# Access Compliance Report

## Public Rights-of-Way

### (Curb Ramps)

Intersection ID: 53747	Main Street: BELVEDERE CASTLE DR	Cross Street: CANTERBURY CASTLE DR	Location: NW
ADA ID: 661BD64D9FB2	Ramp Type: Perp	Initial Pass/Fail: Fail	Overall Compliance: No
Codes/Mitigation Info/Possible Solution		Field Measurements/Component Compliance	
Severity Score: 8.75

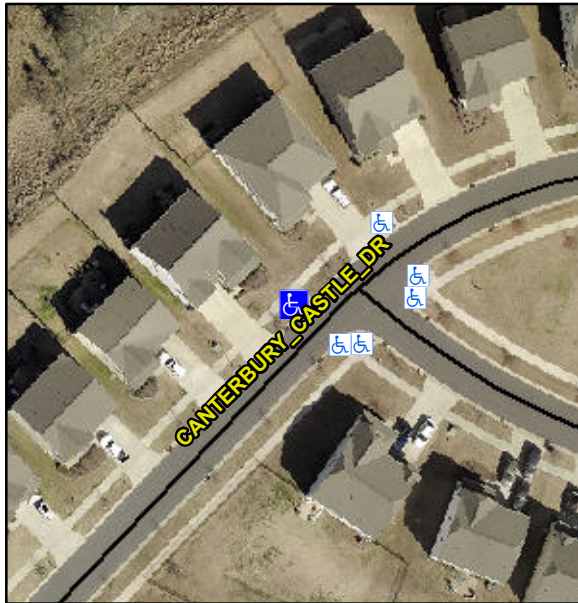
Compliance	Description	Data	Compliance	Description	Data
N/A	Ramp Length (in)	94.0	Yes	Ramp Slope (%)	6.5
No	Ramp Width (in)	46.5	Yes	Ramp XSlope (%)	1.3
N/A	Flare Type LT	N/A	N/A	Flare Type RT	N/A
N/A	Flare Slope LT (%)	N/A	N/A	Flare Slope RT (%)	N/A
N/A	Flare Traversable LT?	N/A	N/A	Flare Traversable RT?	N/A
N/A	Landing Length (in)	N/A	N/A	DWS Provided?	N/A
N/A	Landing Width (in)	N/A	N/A	DWS Contrast?	N/A
N/A	Landing Slope (%)	N/A	N/A	DWS Length (in)	N/A
N/A	Landing X Slope (%)	N/A	N/A	DWS Full Width?	N/A
N/A	Landing Curb? (Y/N)	N/A	N/A	DWS Offset (in)	N/A
N/A	Shared Landing?	N/A			
N/A	Gutter Ponding?	N/A	N/A	Gutter Slope (%)	N/A
N/A	Gutter Lip Ht (in)	N/A	N/A	Gutter X Slope (%)	N/A
N/A	Painted X Walk1?	No	N/A	Painted X Walk2?	N/A
	X Walk 1 Direction	To SE		X Walk 2 Direction	N/A
N/A	X Walk 1 Width (in)	N/A	N/A	X Walk 2 Width (in)	N/A
	X Walk 1 Slope (%)	3.4		X Walk 2 Slope (%)	N/A
	X Walk 1 X Slope (%)	0.9		X Walk 2 X Slope (%)	N/A

**Remove & Replace Entire Ramp.**

**R304.5.1**
